STAFF RECOMMENDATION

NCPC File No. MP03/6805

THE YARDS AT THE SOUTHEAST FEDERAL CENTER

WATERFRONT PARK
M Street and New Jersey Avenue, SE
Washington, D.C.

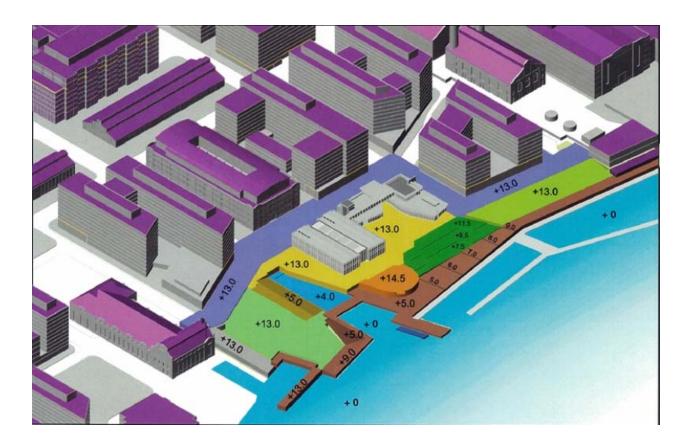
The pedestrian bridge crossing the canal basin, above the bulkhead, looking west from the boardwalk. Tables and chairs can create a café area here. Note the bridge support at the western end of the bulkhead trail: staff recommends that this be restudied to improve improved visual and physical connections as the bridge design is also restudied.
